SUBJECT: FORWARDS RESPONSES TO ROUND ONE, SET THREE QUESTIONS FROM
 AUXILIARY SYS BRANCH. RESPONSES WILL BE INCORPORATED IN FSAR.

Subject: WPPSS NUCLEAR PROJECT NO. 2
RESPONSES TO ROUND ONE
QUESTIONS, SET THREE - ASB

Auxiliary Systems Branch Questions
(10.10 - 10.34)

FIG. 9.27a

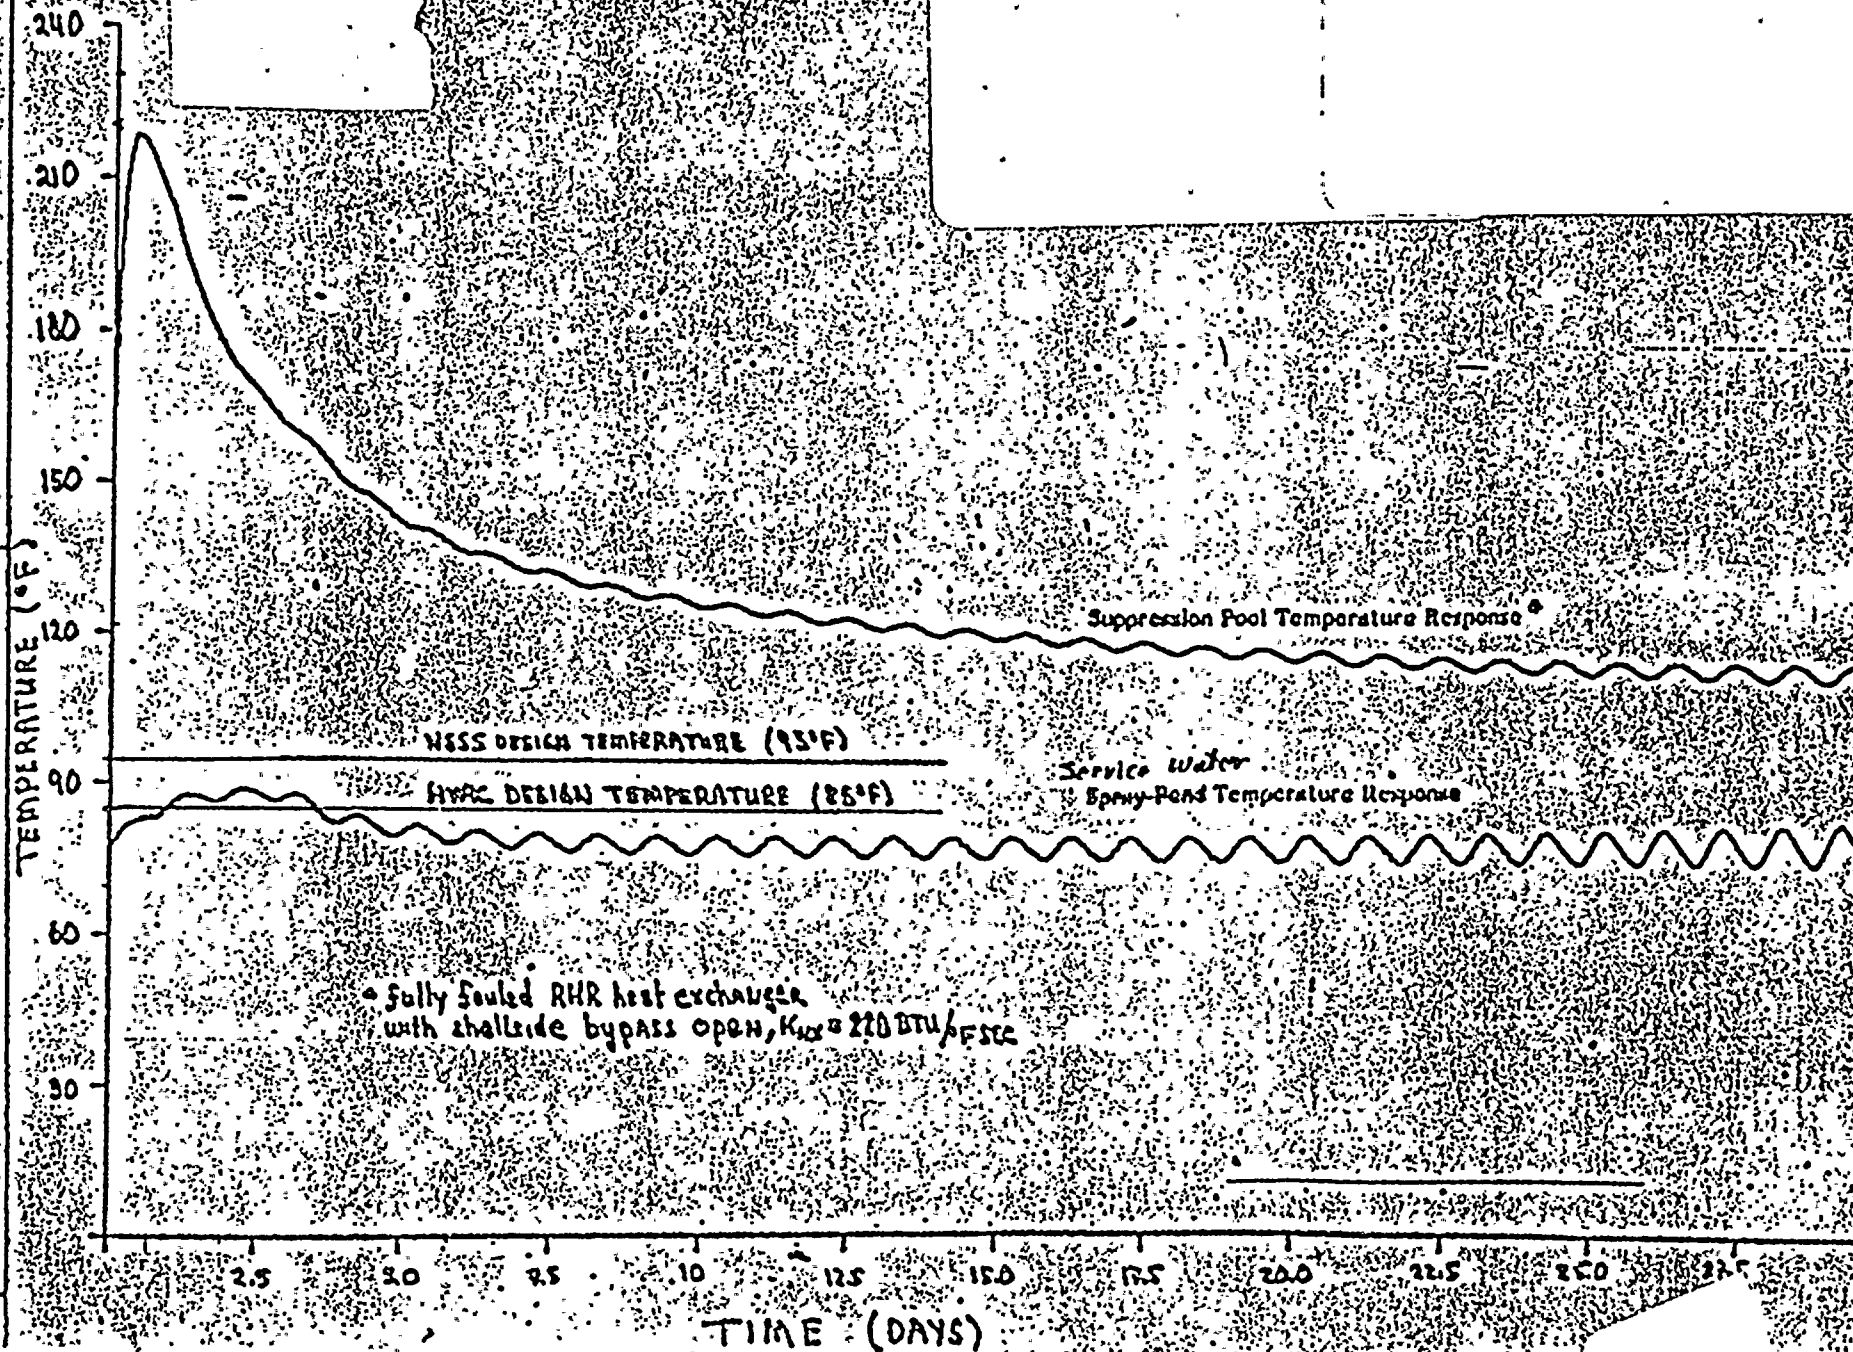
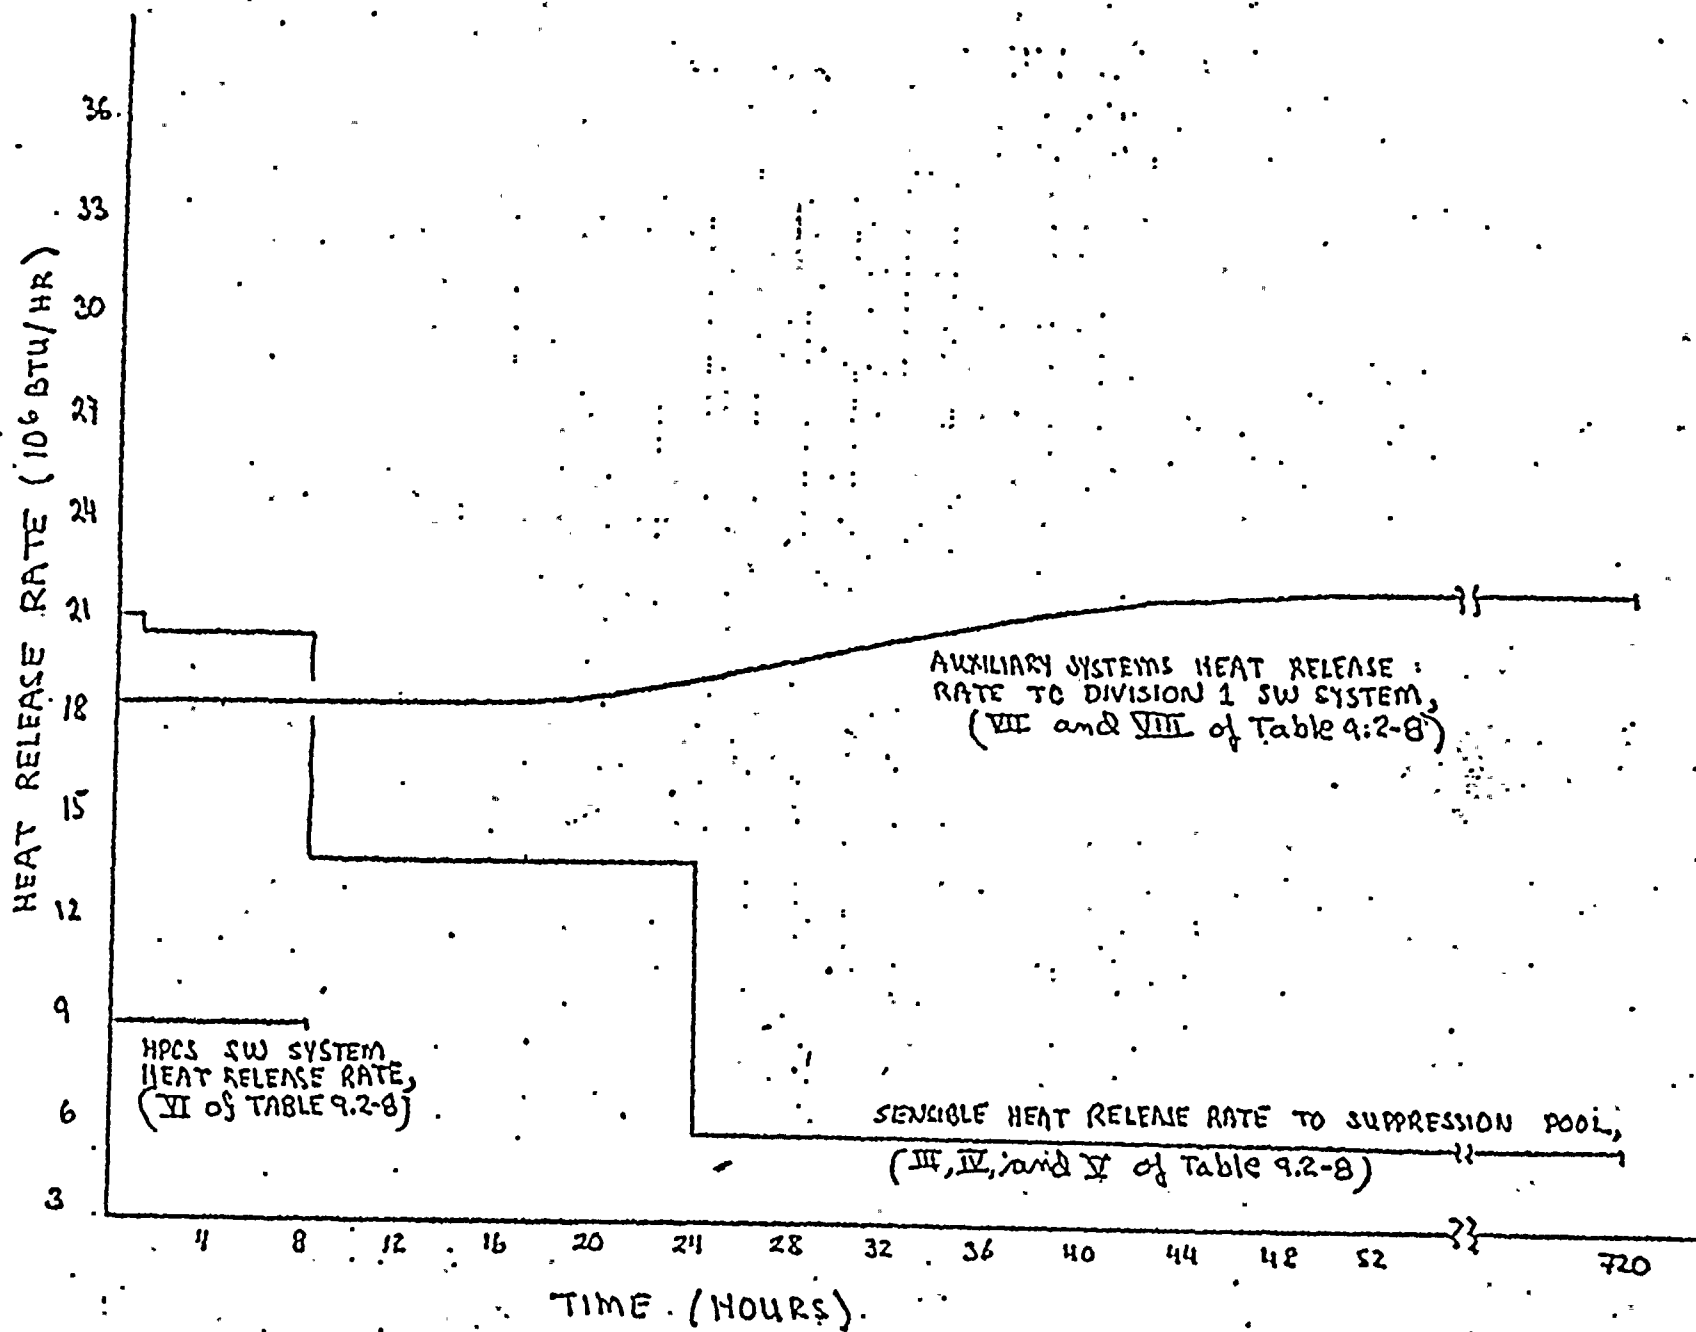
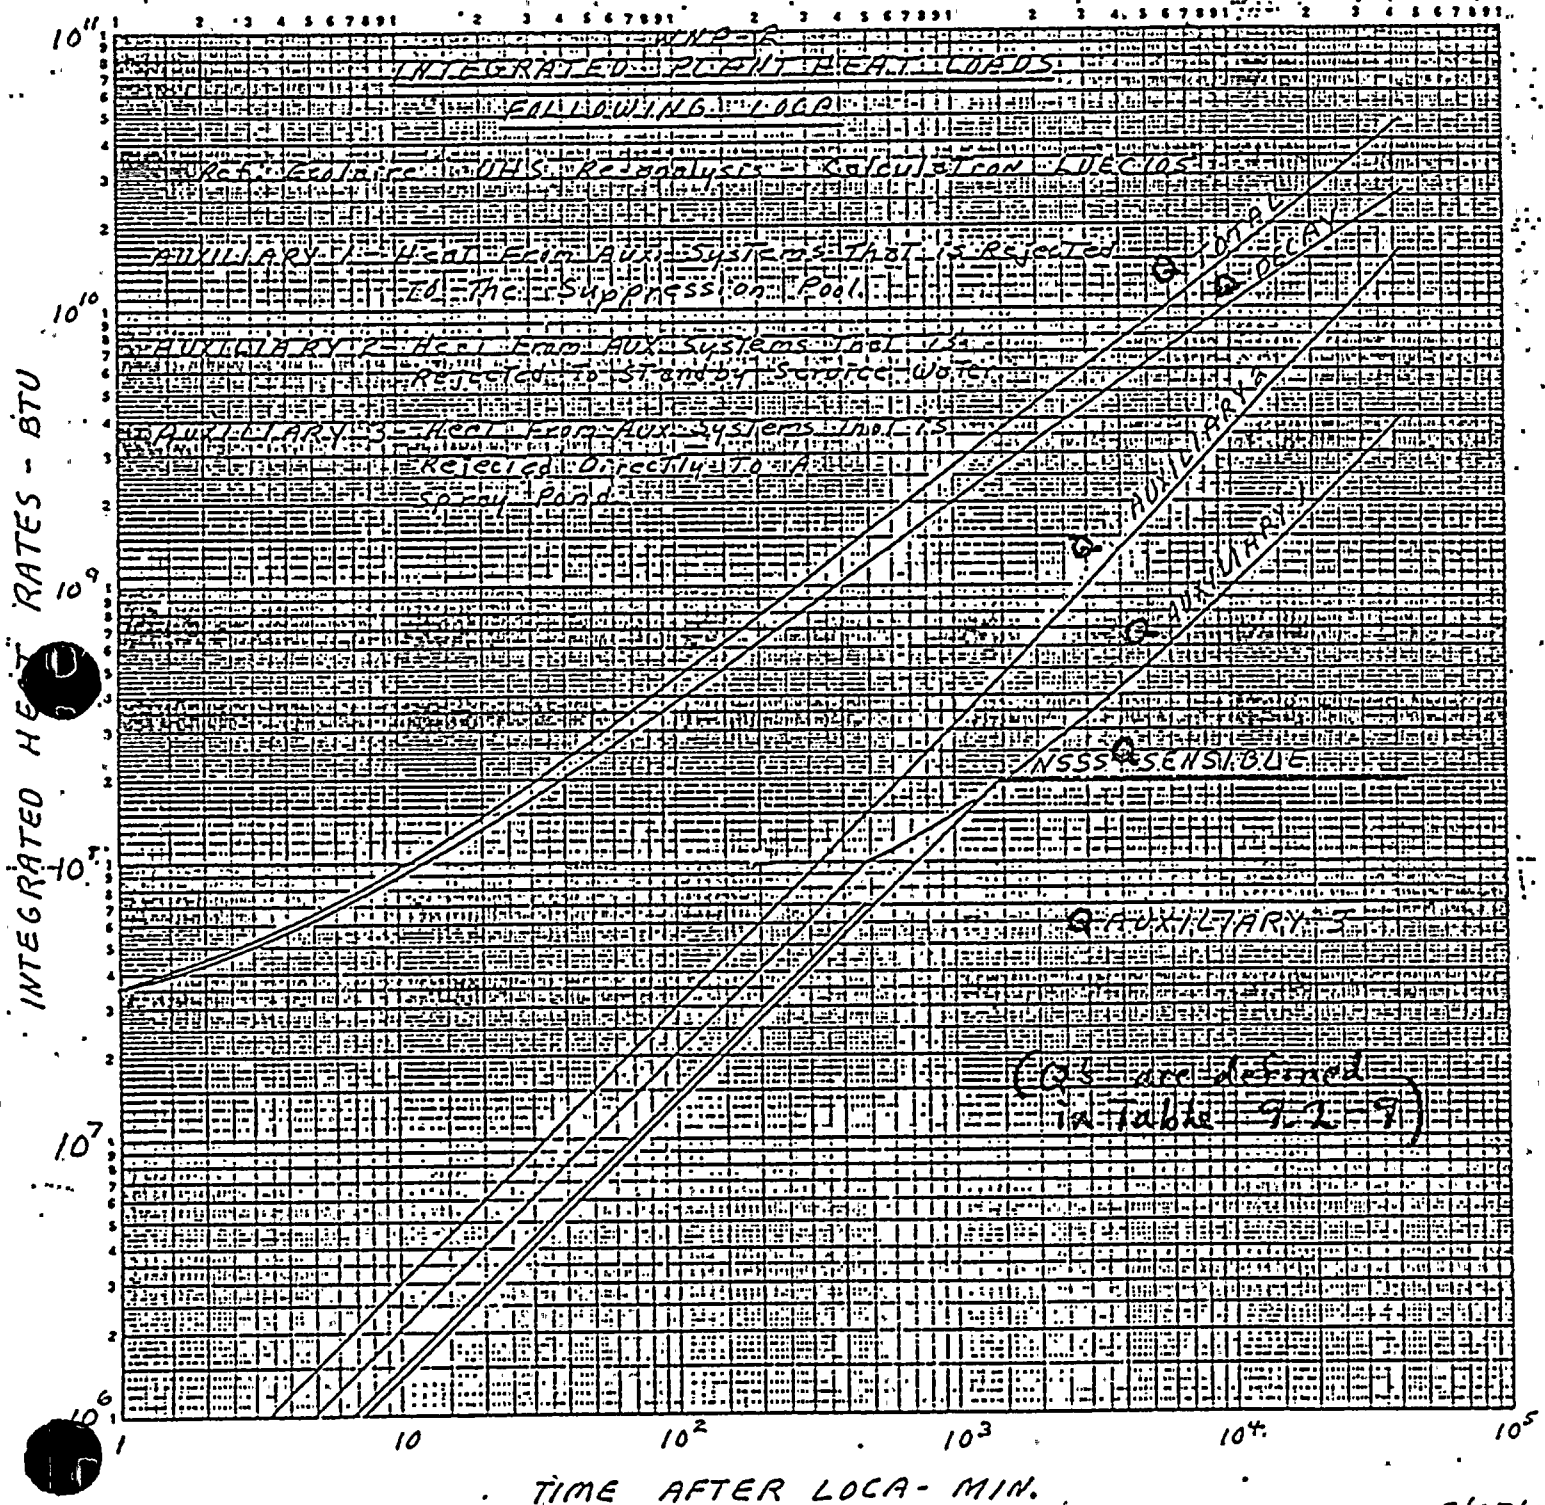
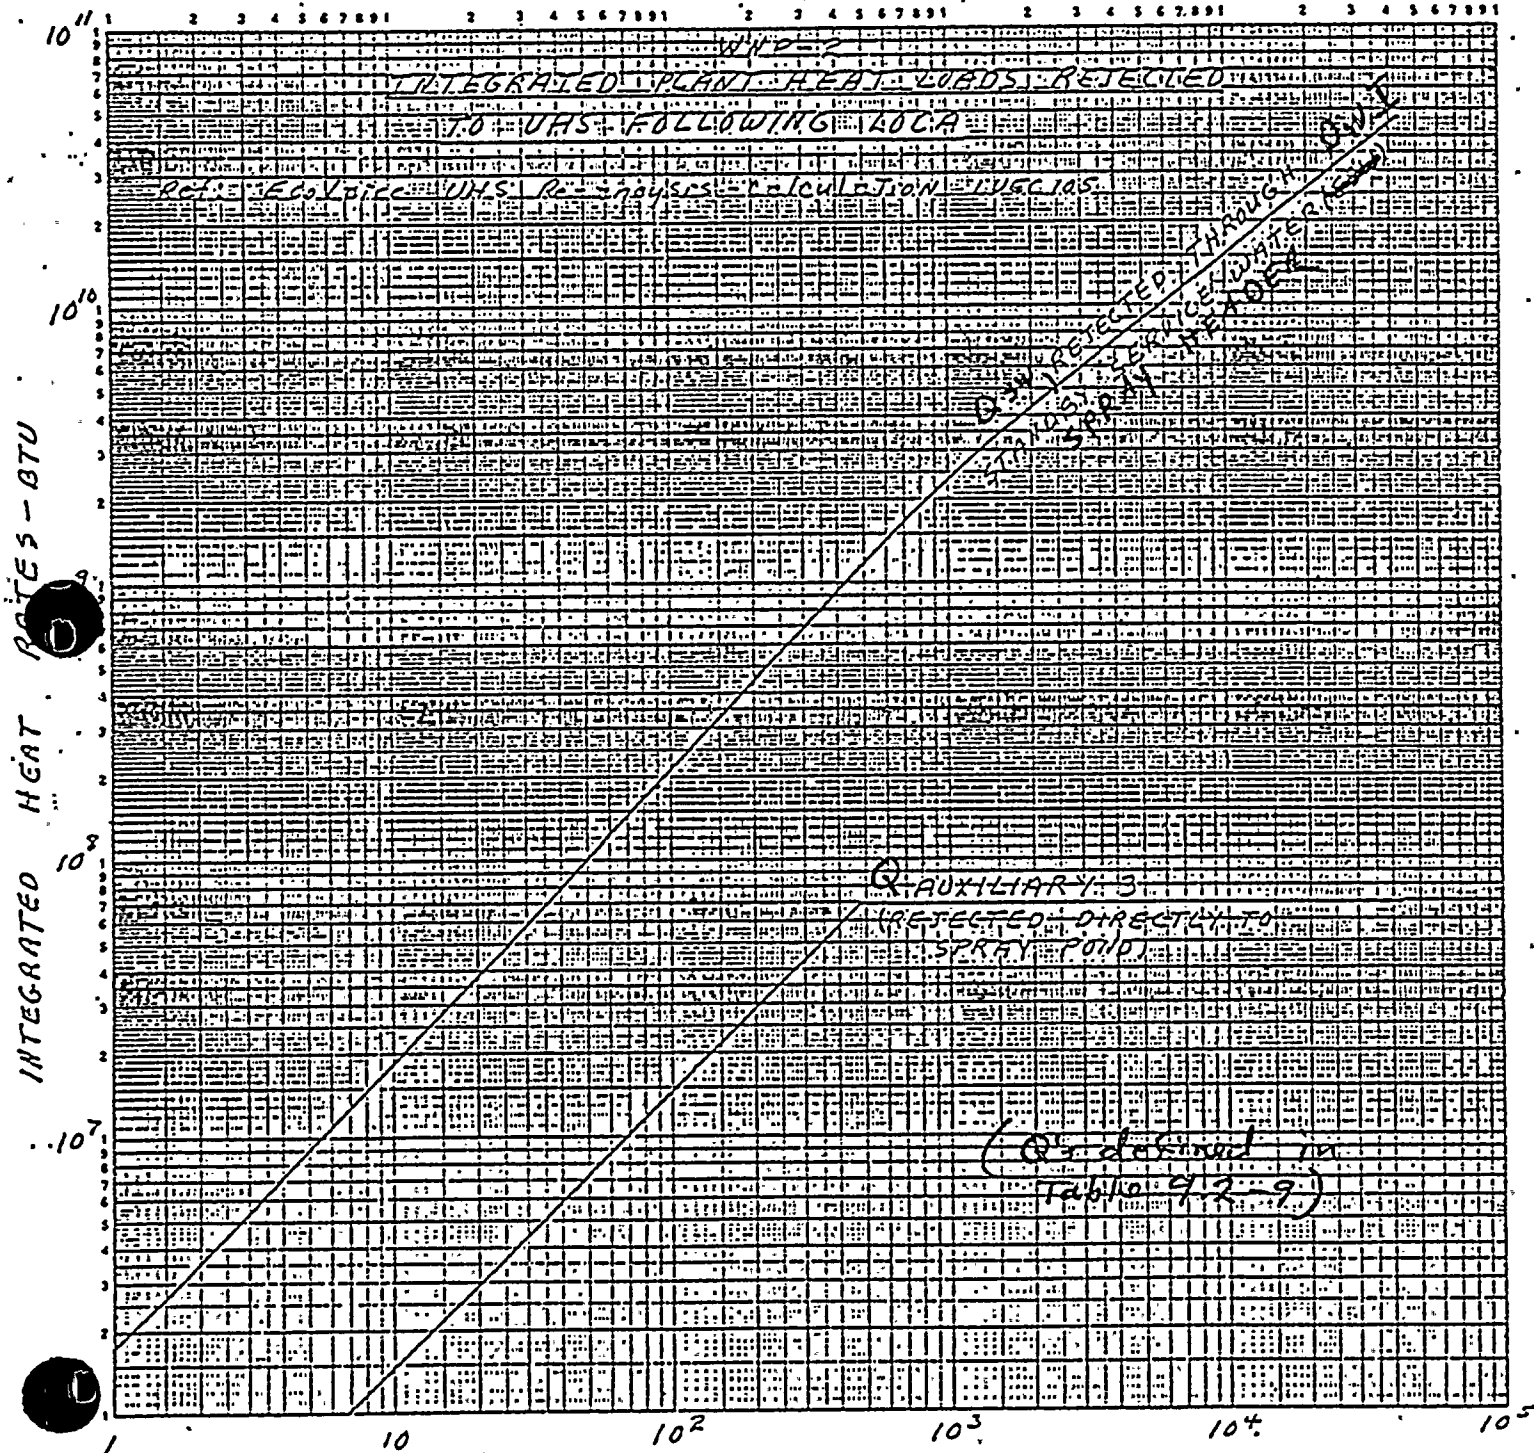
Provide the results of your analysis of the capability of the ultimate heat sink to absorb heat over a thirty-day period following a postulated design basis accident. Indicate the total heat absorbed in the ultimate heat sink, including the sensible heat, the station auxiliary system heat, and the decay heat released by the reactor core. In particular, provide the following information in both tabular and graphical formats:

Using the assumptions stated earlier, two analyses were run. The first assumed a clean RHR heat exchanger and the second assumed a fouled heat exchanger. The pond temperature transient for the first analysis is shown in Figure 9.2-7. The pond temperature peaks at 87.00°F on the thirtieth hour. The mass inventory is shown in Figure 9.2-8, and the mass losses are tabulated in Table 9.2-3. The diurnal oscillations in pond temperature are due to the changes in solar loading. The second analysis yielded a peak pond temperature of 174°F lower and at the same hour after the accident. The only significant difference between the two analyses is
